| <b>Model</b>                   | VT2300/2500, Ges5330, Rex1260, NSA CP330 | <b>Volt/Hz</b> | <b>Date of Modification</b> | <b>Serial Number</b> |
| <b>Modified Article</b>        | Parts Catalog                            |                |                             |                      |
| <b>Reason for Modification</b> | Parts catalog correction                 |                |                             |                      |

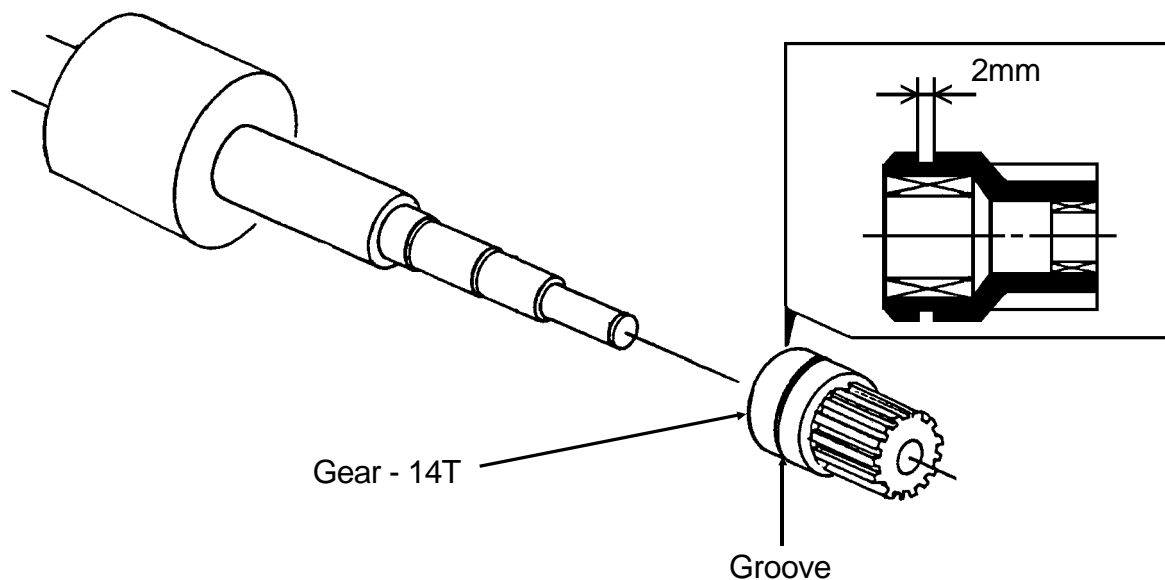
| <b>Model</b>                   |               | VT2300/2500, Ges5330, Res1260, NSA CP330              |             |        |                        |                     | <b>Volt/Hz</b>                          | <b>Date of Modification</b> | <b>Serial Number</b> |      |
|--------------------------------|---------------|---|-------------|--------|------------------------|---------------------|---|-----------------------------|----------------------|------|
| <b>Reason for Modification</b> |               | To improve the durability of the 2nd feed roller gear |             |        |                        |                     |   |                             |                      |      |

It was reported that on some machines in the field, the image position varies. Although this is a very rare case, at worst this happened after making about 200,000 prints. On the problem machine, the one-way clutch inside the 2nd feed roller gear slips just when the 2nd feed rollers start feeding a sheet. (The paper feed start timing is delayed.) This makes the image position vary, i.e. move up or down in paper feed direction. After investigation, it was found that the grease inside the one-way clutch changes in quality and damage the inside surface of the clutch. The new 2nd feed roller gear contains a new type of grease that does not change in quality unlike the old one. To distinguish the new gear from the old one, a groove is made on the new gear.

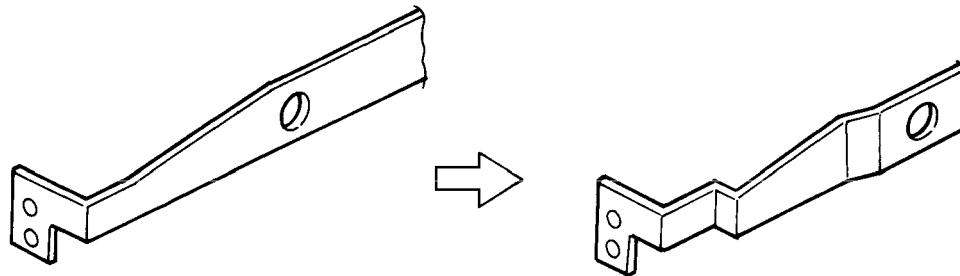
| <b>Model</b>                   |               | VT2300/2500, Ges5330, Rex1260, NSA CP330                               |                 |        |                        |                     | <b>Volt/Hz</b>                          | <b>Date of Modification</b> | <b>Serial Number</b> |      |
|--------------------------------|---------------|--|-----------------|--------|------------------------|---------------------|---|-----------------------------|----------------------|------|
| <b>Reason for Modification</b> |               | To prevent the feed roller arm from touching the paper feed side plate |                 |        |                        |                     |   |                             |                      |      |

When the paper table is lowered, the feed roller arm contacts the side pad lever if the paper feed side plates are fully opened. To prevent this, the shape of the feed roller arm has been changed as shown in the illustration below.

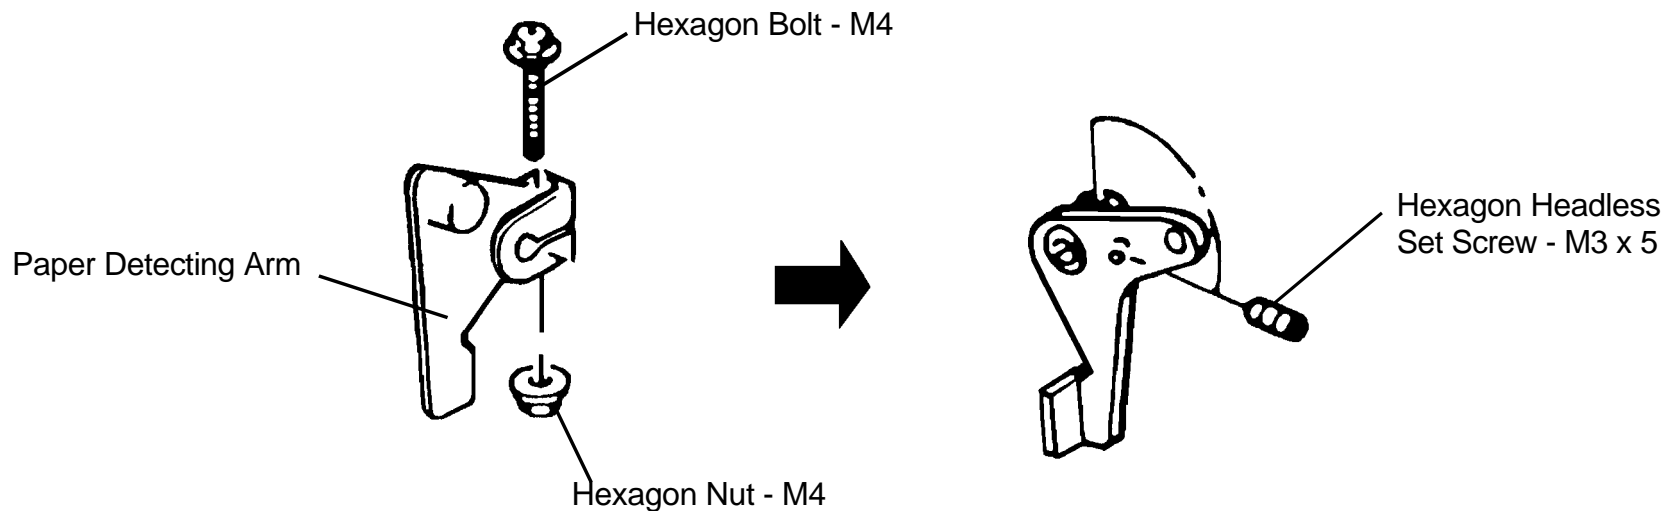
| Model                   |               | VT2300/2500, Ges5330, Rex1260, NSA CP330                      |                                     |        |                        |                     | Volt/Hz                                 | Date of Modification | Serial Number |      |
|-------------------------|---------------|---|-------------------------------------|--------|------------------------|---------------------|---|----------------------|---------------|------|
| Reason for Modification |               | To improve strength and durability of the paper detecting arm |                                     |        |                        |                     |   |                      |               |      |

To improve strength and durability, the paper detecting arm has been changed to the type used on the NA2 (C210).

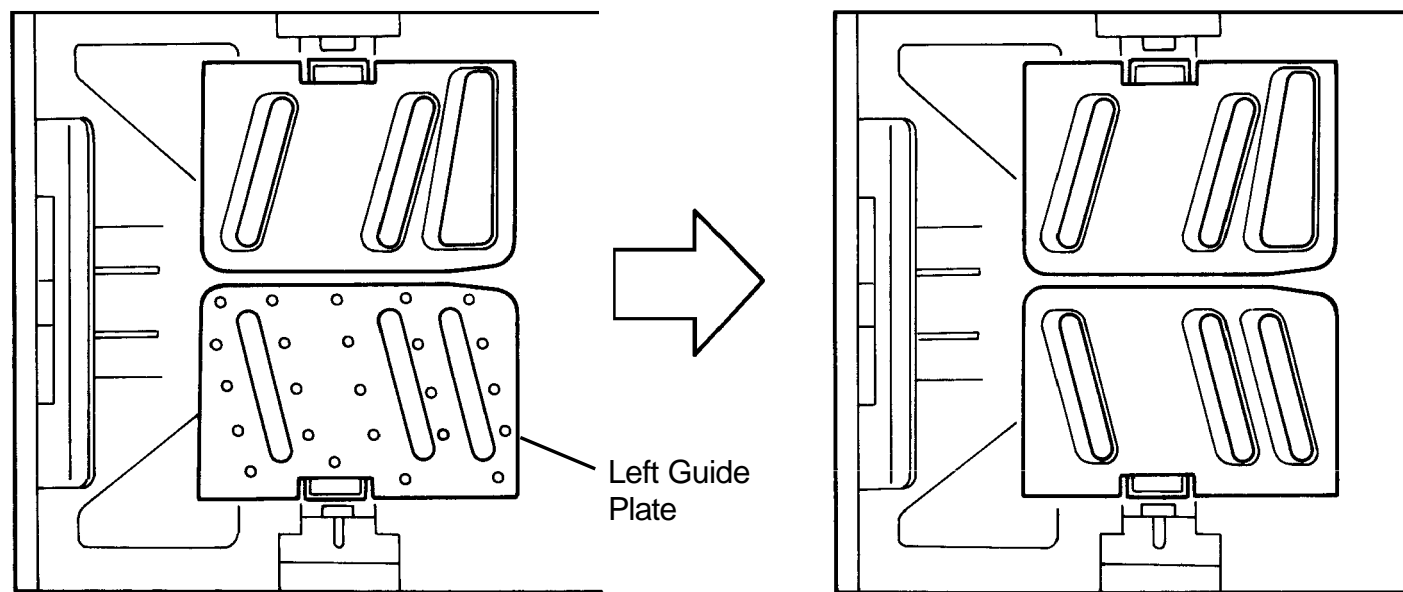
| <b>Model</b>                   |               | VT2300/2500, Ges5330, Rex1260, NSA CP330             |                  |        |                        |                     | <b>Volt/Hz</b>                          | <b>Date of Modification</b> | <b>Serial Number</b> |      |
|--------------------------------|---------------|--|------------------|--------|------------------------|---------------------|---|-----------------------------|----------------------|------|
| <b>Reason for Modification</b> |               | To match the appearance of the Delivery Guide Plates |                  |        |                        |                     |   |                             |                      |      |

The right guide plate of the priport VT2000 series was changed from that of the priport SS series in order to allow for the installation of the tape dispenser unit. As a result, the appearance of the right guide plate was different from the old one. This was visible especially when the right and left guide plates were closed. (See figure)

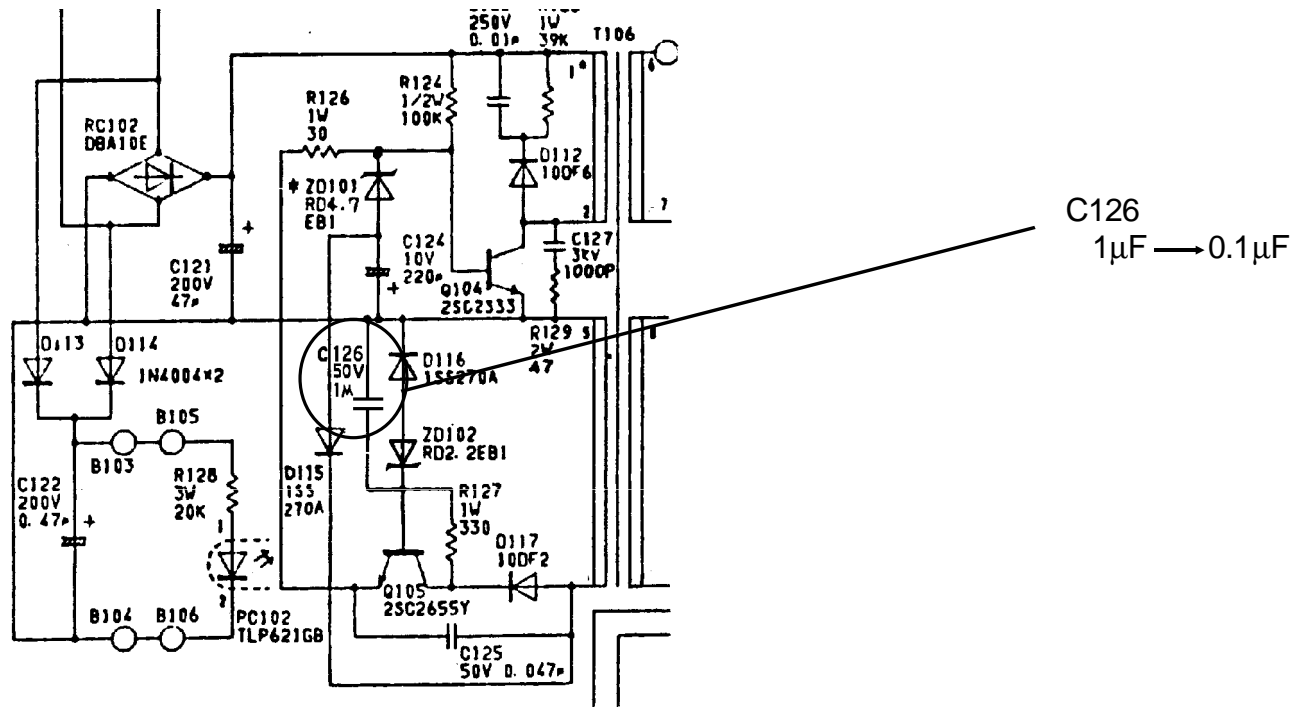
| Model                   |               | VT2300/2500, Ges 5330, Rex 1260, NSA CP330          |                               |        |                        |                     |   | Volt/Hz     | Date of Modification | Serial Number |  |
|-------------------------|---------------|---|-------------------------------|--------|------------------------|---------------------|---|-------------|----------------------|---------------|--|
| Reason for Modification |               | To improve the response of the power supply circuit |                               |        |                        |                     |   |             |                      |               |  |

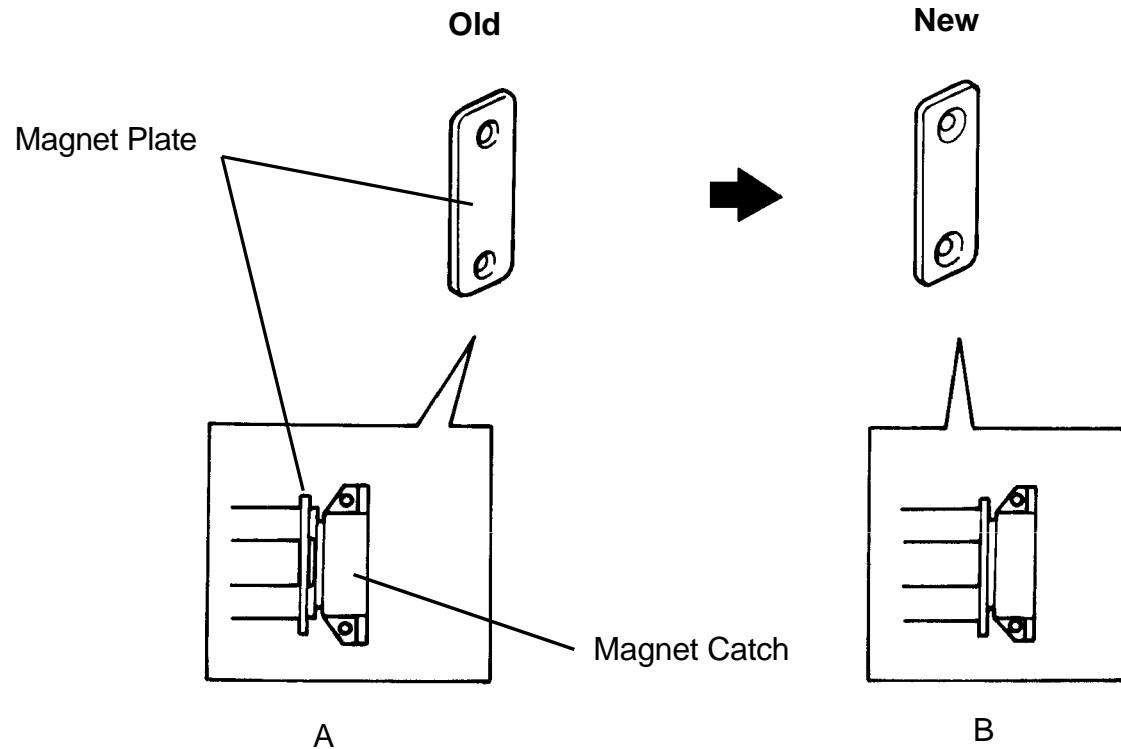
In VT series, the flat head screws fixing the magnet plate project out of the holes of the magnet plate because the heads of the screws are a little bigger than the holes. This weakens the attraction between the magnet catch and the magnet plate (illustration A).

To increase the attraction, the holes of the magnet plate have been made bigger so that the magnet sticks the magnet plate tightly (illustration B).

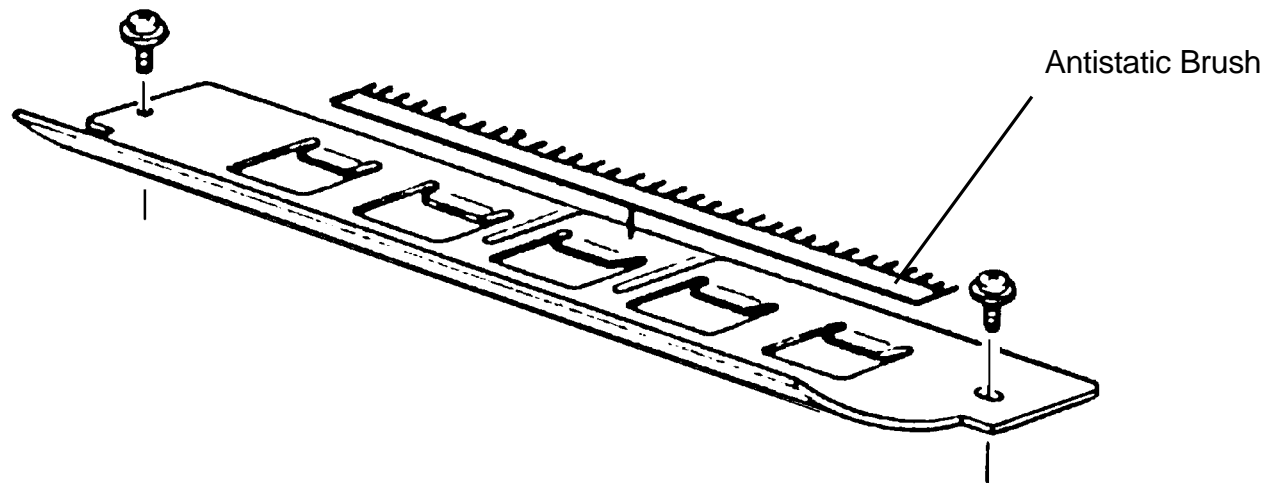
| <b>Model</b>                   |               | VT2300/2500, Ges5330, rex1260, NSA CP330 |                  |        |                        |                     | <b>Volt/Hz</b>                          | <b>Date of Modification</b> | <b>Serial Number</b> |      |
|--------------------------------|---------------|--|------------------|--------|------------------------|---------------------|---|-----------------------------|----------------------|------|
| <b>Reason for Modification</b> |               | To prevent paper jamming around the drum |                  |        |                        |                     |   |                             |                      |      |

To prevent paper jamming under low humidity conditions caused by static electricity on the paper, an antistatic brush is added on the upper second feed roller guide plate. Refer to RTB No. 3 for details.

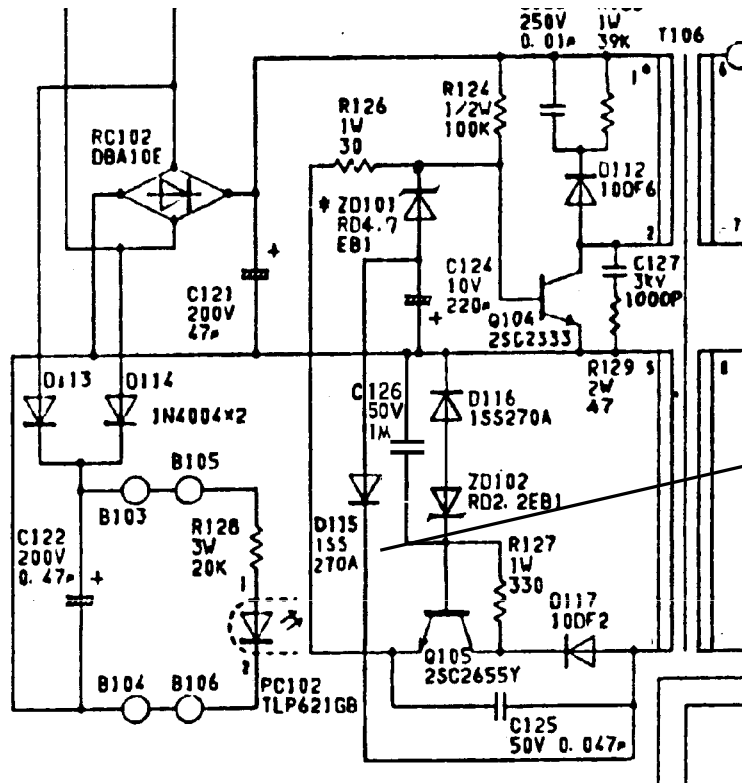
To ensure that the power supply circuit responds quickly (Refer to the MB No. 7), a ferrite core is added to the anode of the diode D115.

Part number of the power supply unit has not been changed but suffix has been changed to B.

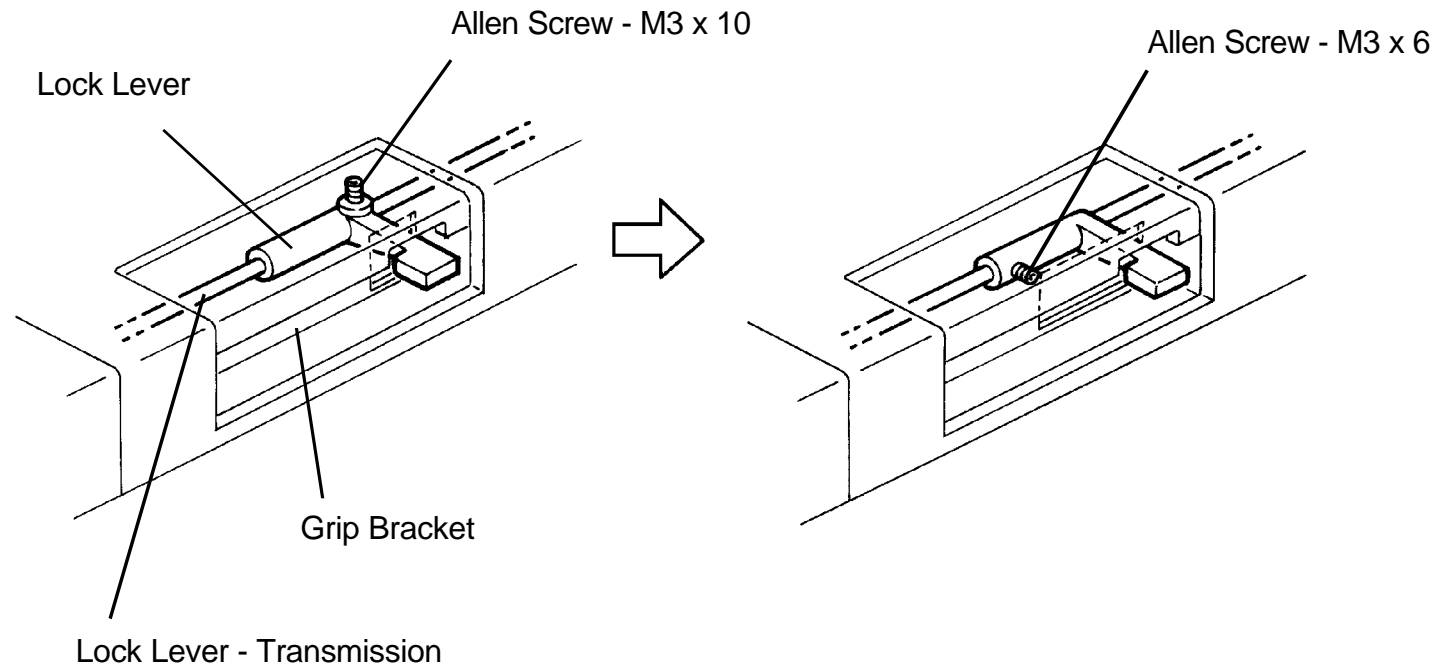
In the present machines, it is difficult to tighten the screw fixing the lock lever to the shaft. It is necessary to remove the scanner unit to access the screw.

To facilitate servicing, the direction of the screw has been changed and the cutout of the bracket has been enlarged so that a customer engineer can access the screw from the cutout of the bracket.

Illustration 1

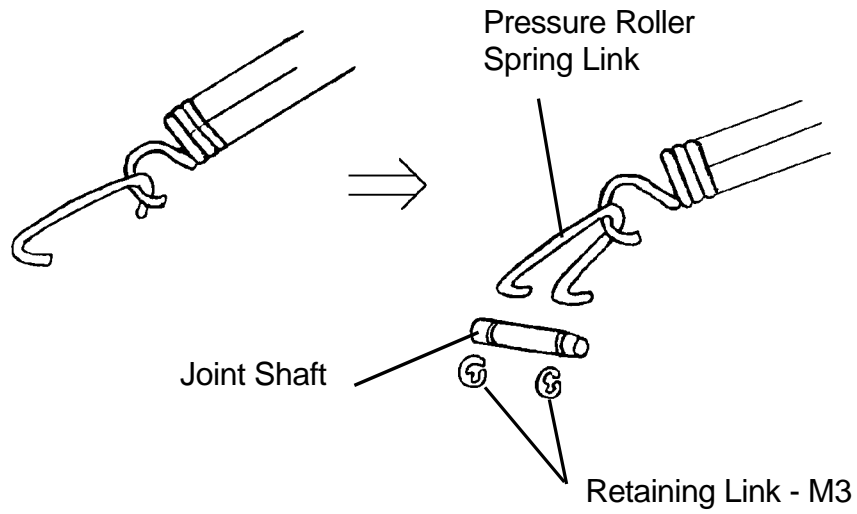
To increase the reliability, the pressure spring link is modified as shown in the illustration 1. Due to this modification, the adjustment value of the bolt clearance [A] has been changed as shown in the illustration 2.

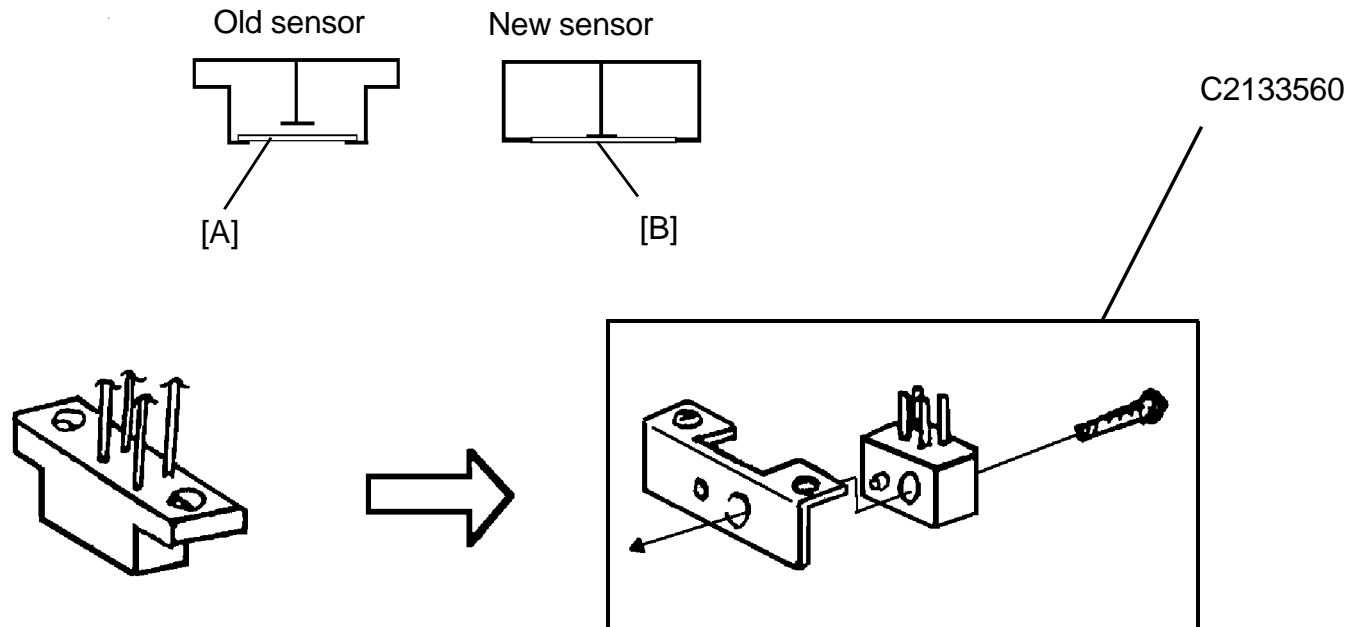
It is sometimes reported that the master eject sensor does not detect the ejected master. This problem happened when the filter [A] was out of position. To prevent this, the drum master detection sensor has been modified. The filter [B] of the new sensor is fixed in position.
